# 624 YALE APARTMENTS

DESIGN REVIEW  
RECOMMENDATION

## YALE AVENUE N GARAGE ENTRY

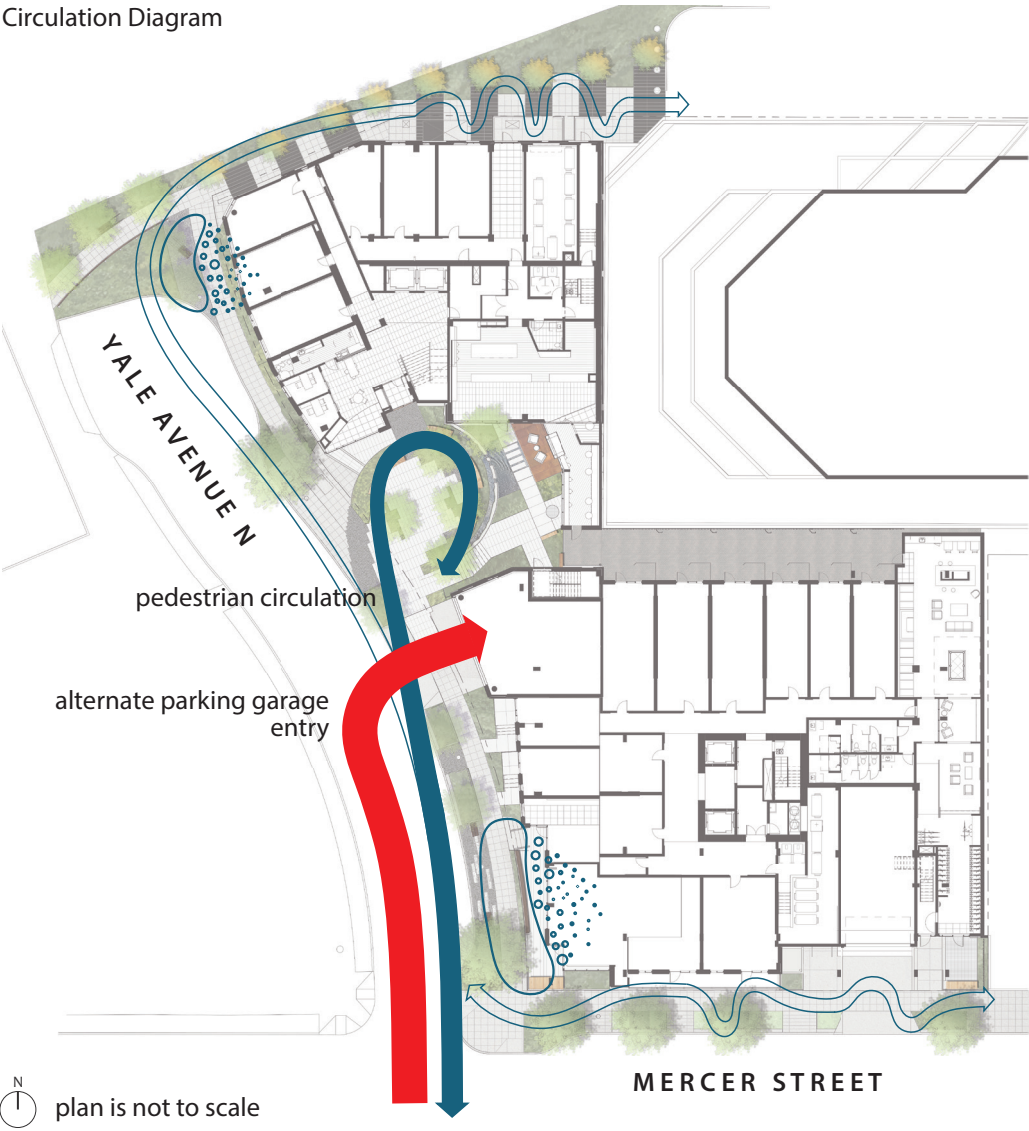
At the EDG meeting, the board requested exploration of the driveway entry on Yale Avenue N, instead of Mercer Street. This alternative significantly impacts the pedestrian circulation through the site and negatively impacts the open space. Therefore we propose to maintain the driveway on Mercer Street. Parking and traffic study indicates no significant additional delays or vehicle backups on Mercer Street due to this location.
